The fuseholder OGN has new ratings and approvals as follow:

| Product Change Notification |               |              |             |                 | OGN new approval |        |             |

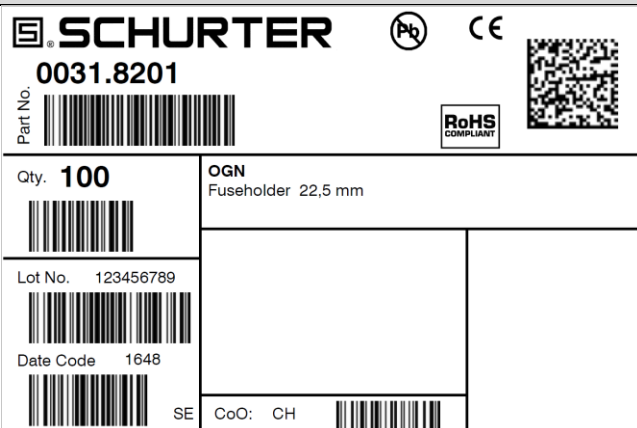
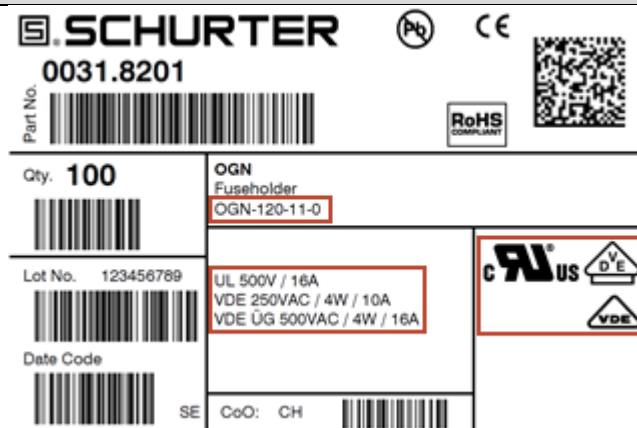
- Modified label
- Improved electrical ratings
- Change of markings

| Label         | Yes | Approvals and configuration code on label |

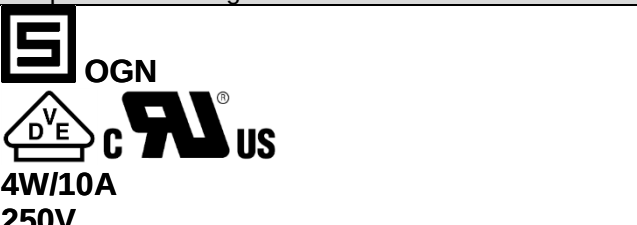
| Form          | Yes | Inscription on socket changed             |
